**BID: CPST-09  
RECREATION COMPLEX RENOVATION & EXPANSION**

**Addendum #1  
dated 6-22-2017**

COLLETON COUNTY  
RECREATION CENTER ADDITION AND RENOVATION  
280 RECREATION LN., WALTERBORO, SC 29488

PROJECT NUMBER  
 13674.00  
**S101**  
 DRAWING NUMBER

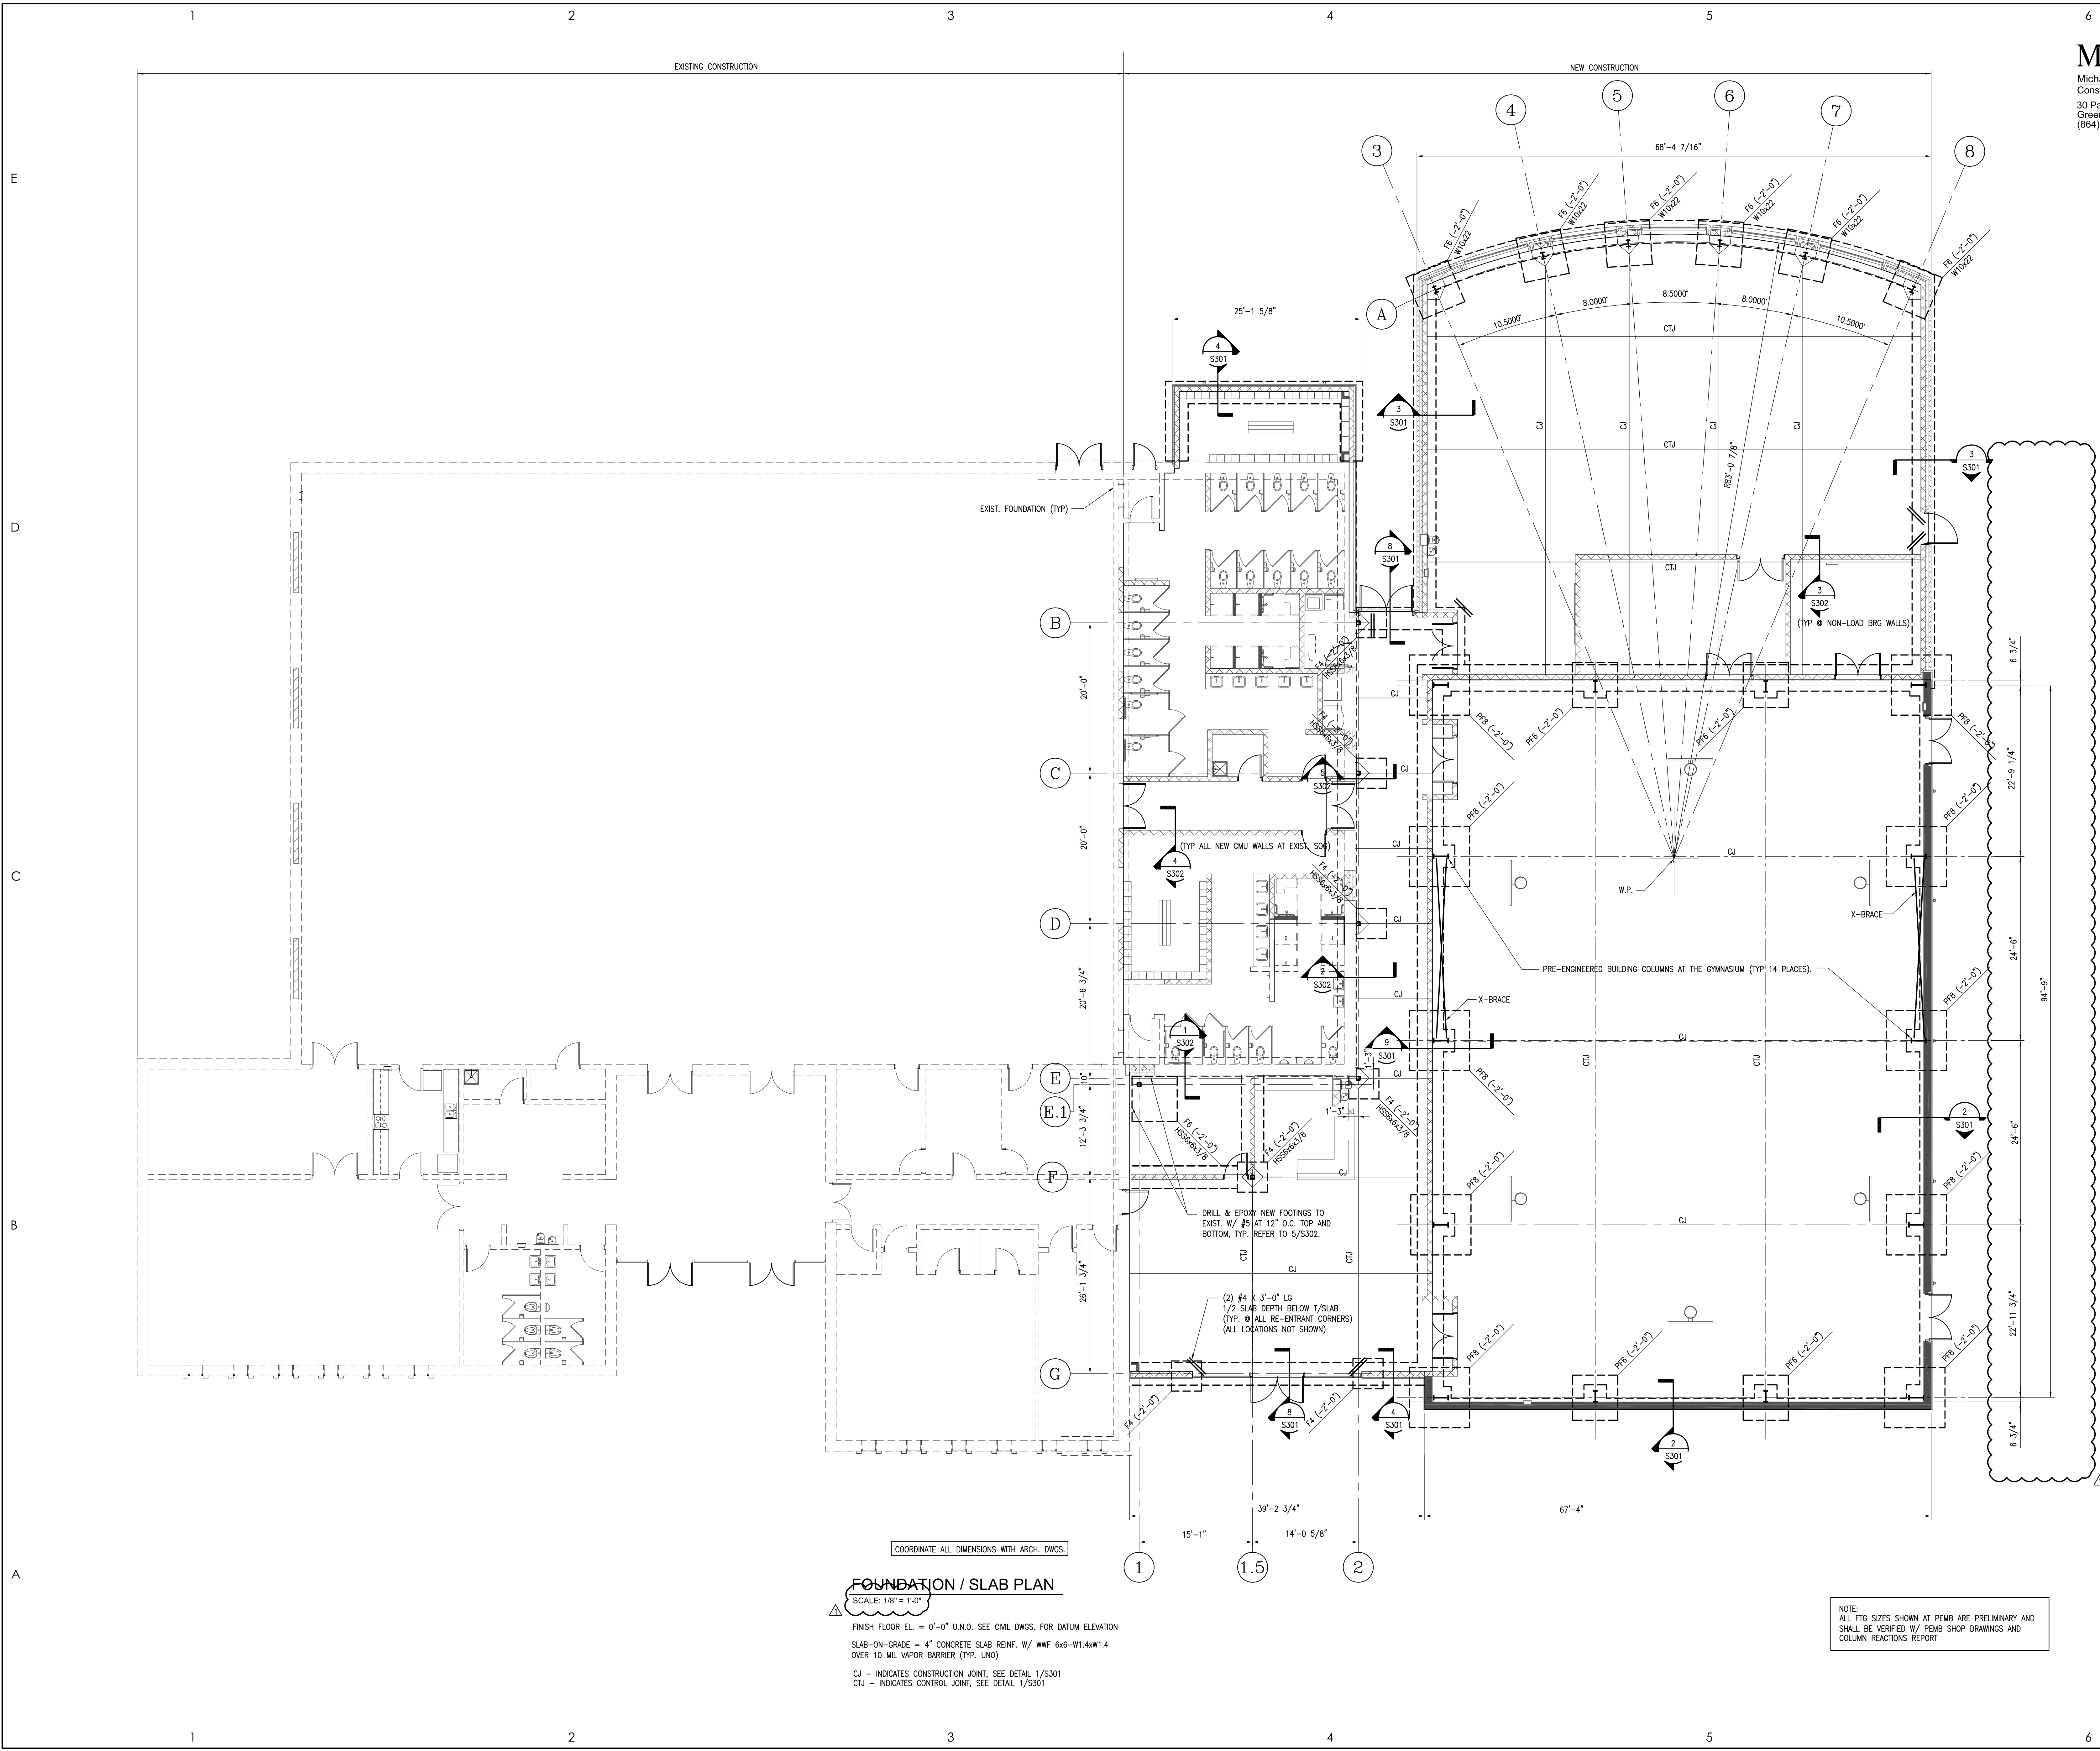
- c. **Gym Plan South Wall – Plywood up to 17'-4"**
15. What is the size of the polished block? **Answer:** **4" x 8" x 16" nominal.**
16. For footing sections 3 S301, 4 S301 and 8 S301, what is the rebar detail for the continuous footings? **Answer:** **See attached drawings.**

32. Structural page S101 has a scale noted as 1/4". Isn't this page 1/8" scale?  
**Answer:** See attached drawings.

**CC**  
**A701**  
 DRAWING NUMBER

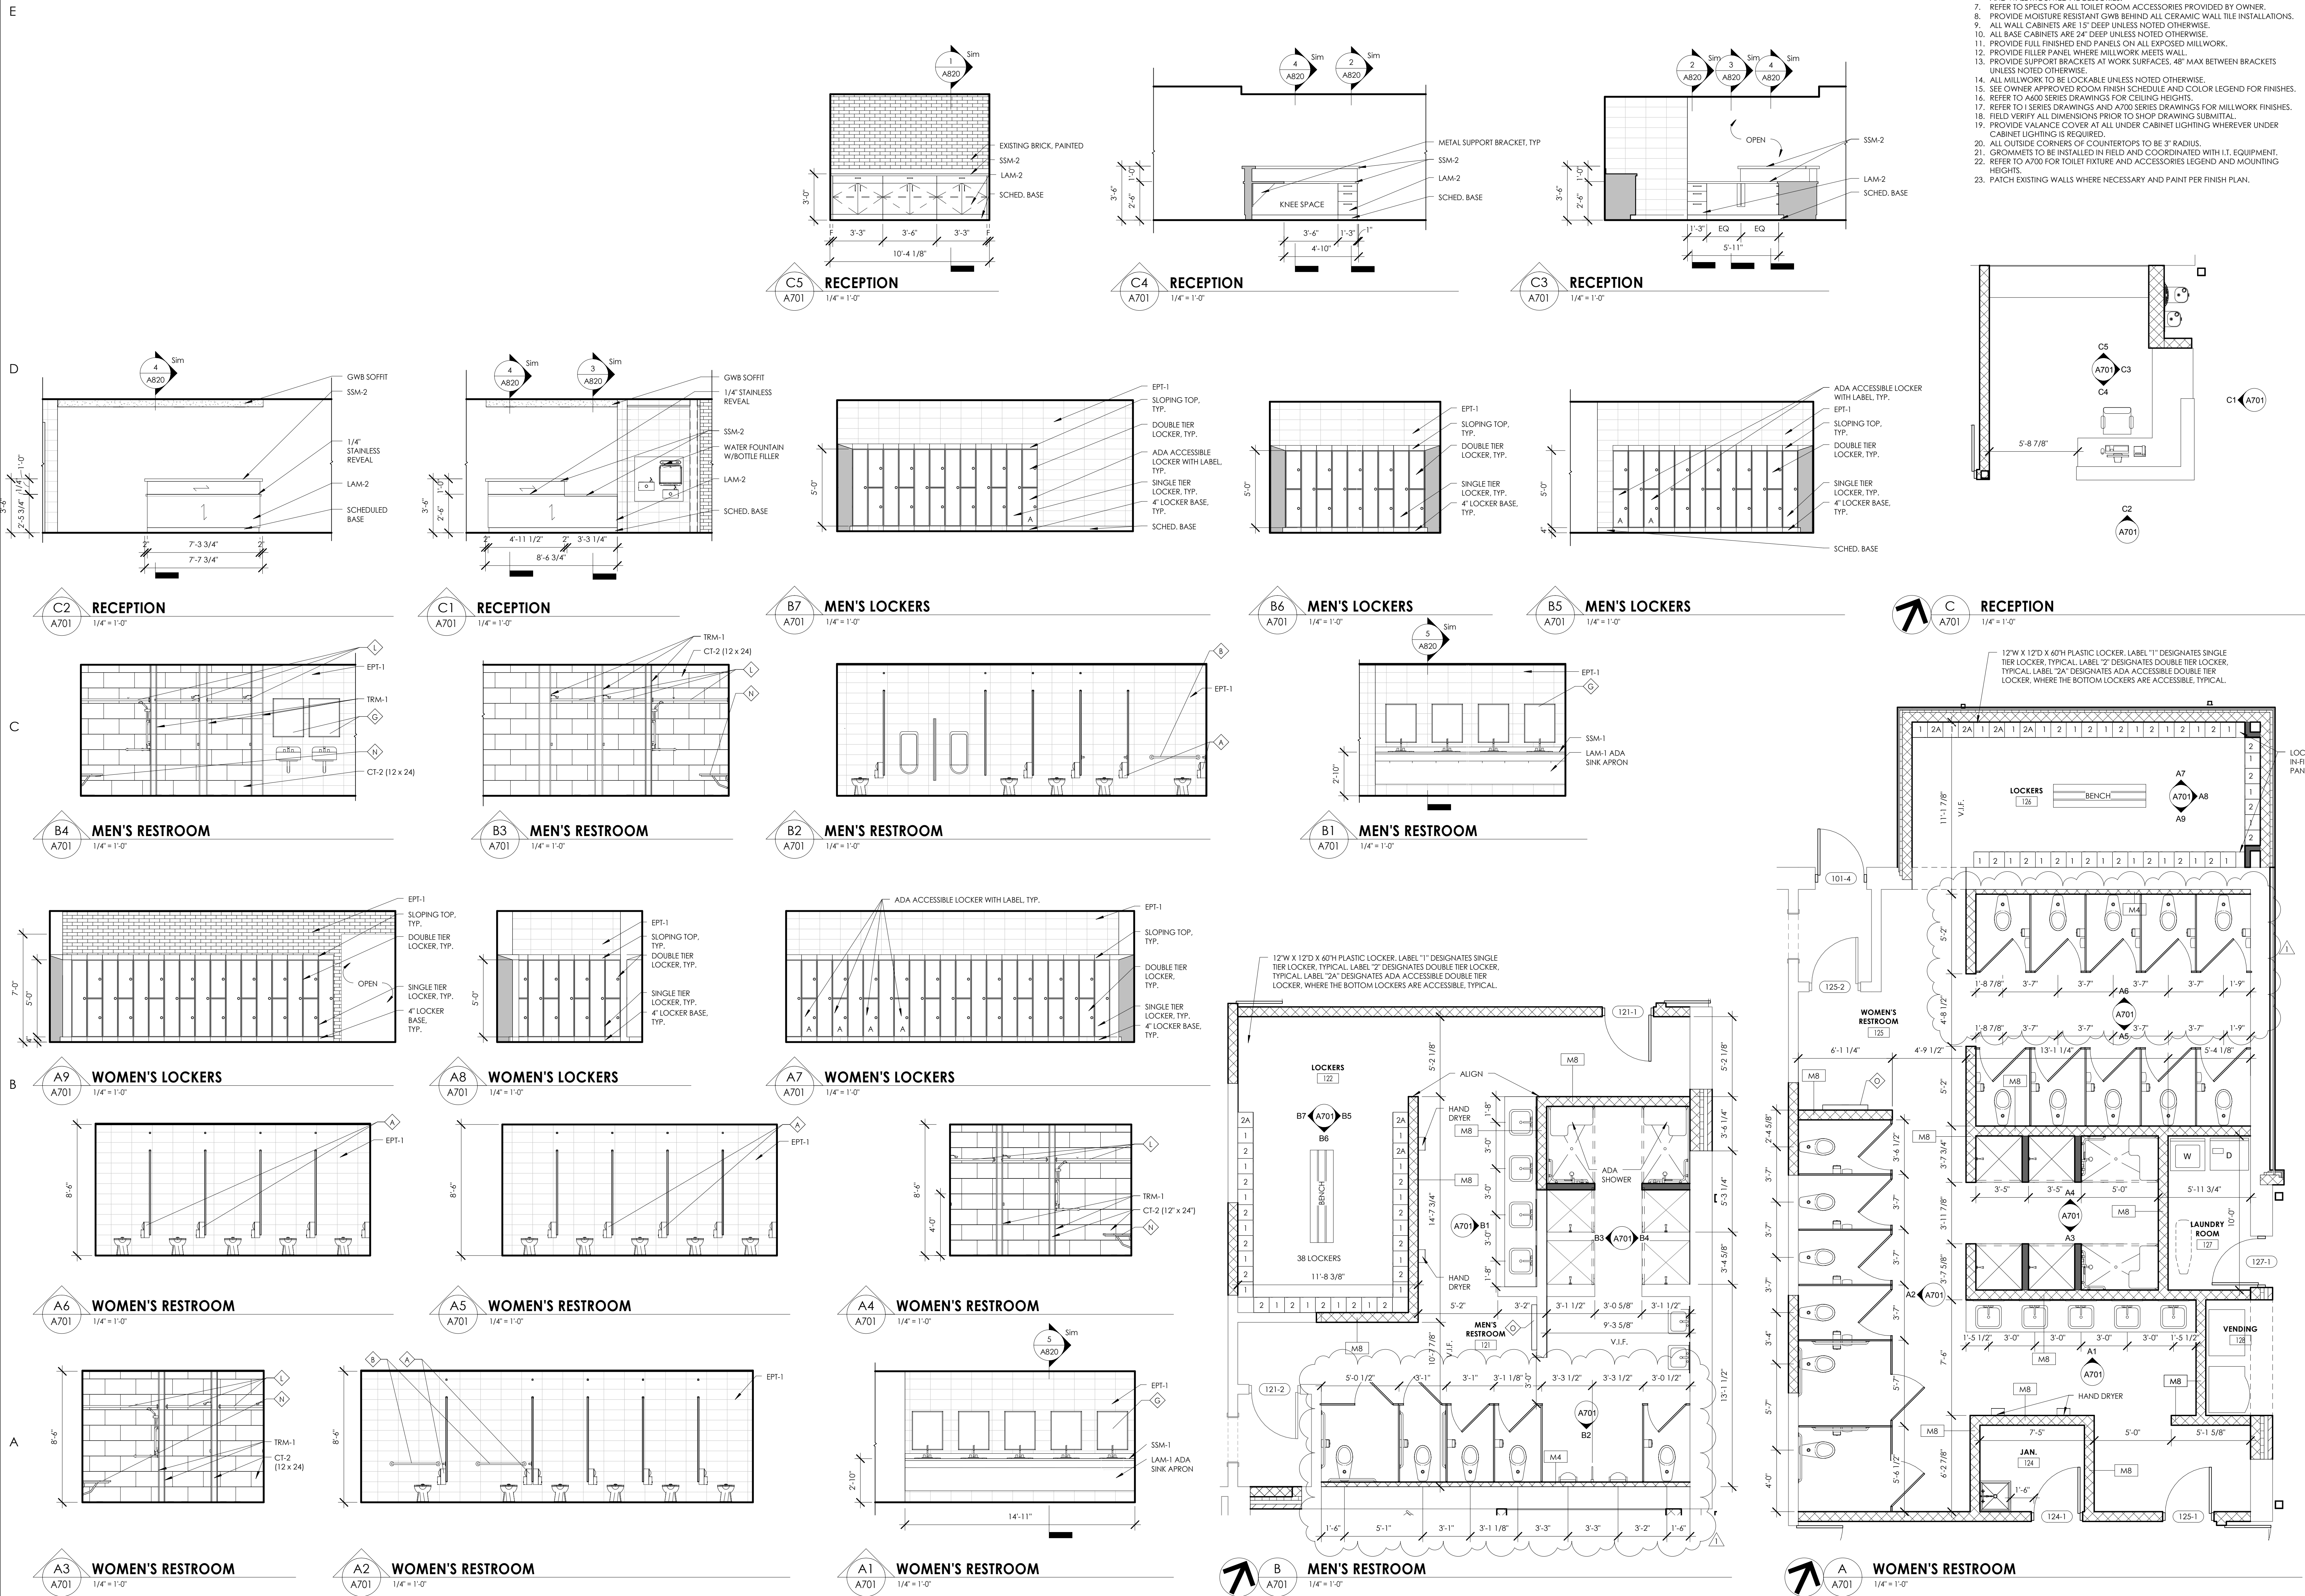
30. Plumber asked me how they are to get the toilet supply into a block wall in the remolded rest rooms? No detail to fur out the wall. He says there is no way to get into the wall now and run water. **Answer:** In Women's Locker Room plan west wall plumbing will have to enter wall above ceiling and wall will have to be chiseled to accommodate piping. At 3 toilet locations part of wall is new and will not require full height chiseling. In Women's Locker Room plan north wall a 4" nominal CMU fur out will be added to the Locker Room side of the wall to accommodate the piping. In Men's Locker Room plan south wall a 4" nominal CMU fur out will be added to the Locker Room side of the wall to accommodate the piping. Refer to revised drawing A701.
